R66 SERVICE LETTER SL-24

SUBJECT: F642 Shaft (Engine-to-Main Gearbox) Upgrade

ROTORCRAFT AFFECTED: R66-series helicopters equipped with a cargo hook or agricultural sprayer and an F642-1 or F642-6 shaft. NOTE: R66 Helicopter S/Ns 0726 & subsequent were factory-fitted with an F642-7 shaft.

FIGURE 1

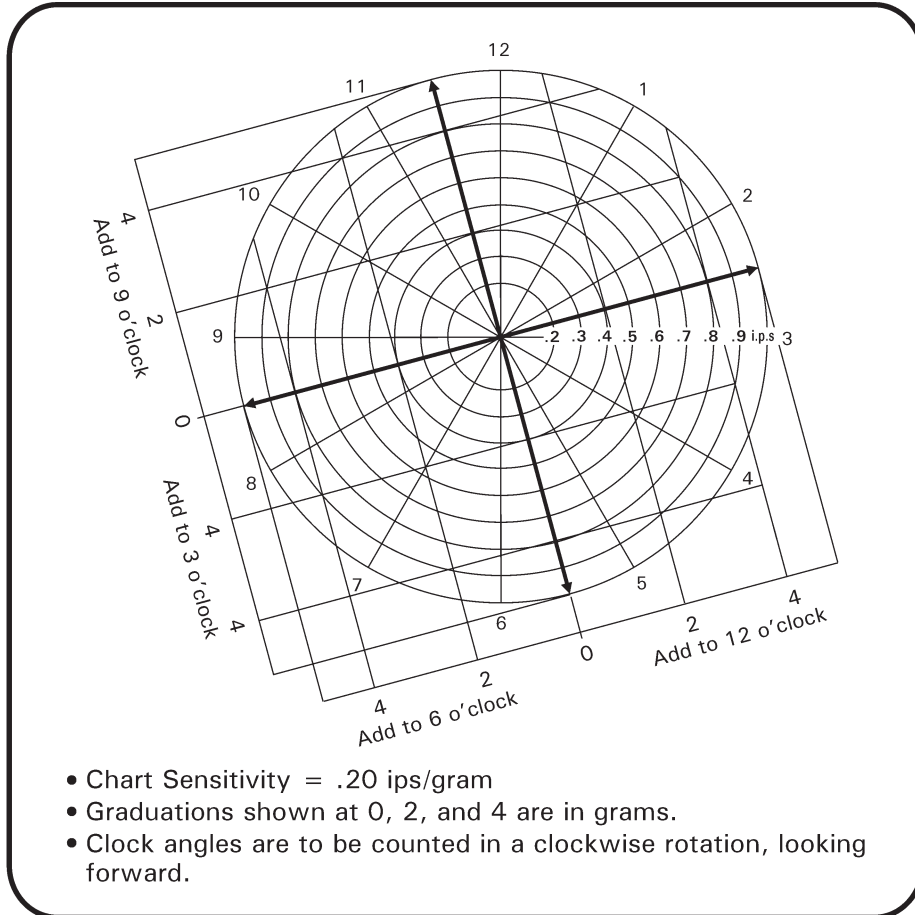
1. If helicopter is equipped with a cargo hook or agricultural sprayer and an F642-1 or F642-6 shaft, order one R9535 kit from RHC Customer Service.
2. Remove F642-1 or F642-6 shaft per R66 Maintenance Manual (MM) § 63-10 and install F642-7 shaft per MM § 63-10. See note below for new hardware included with kit.
3. Balance shaft per MM § 18-70 in conjunction with chart in Figure 1.
4. Make appropriate maintenance record entries.
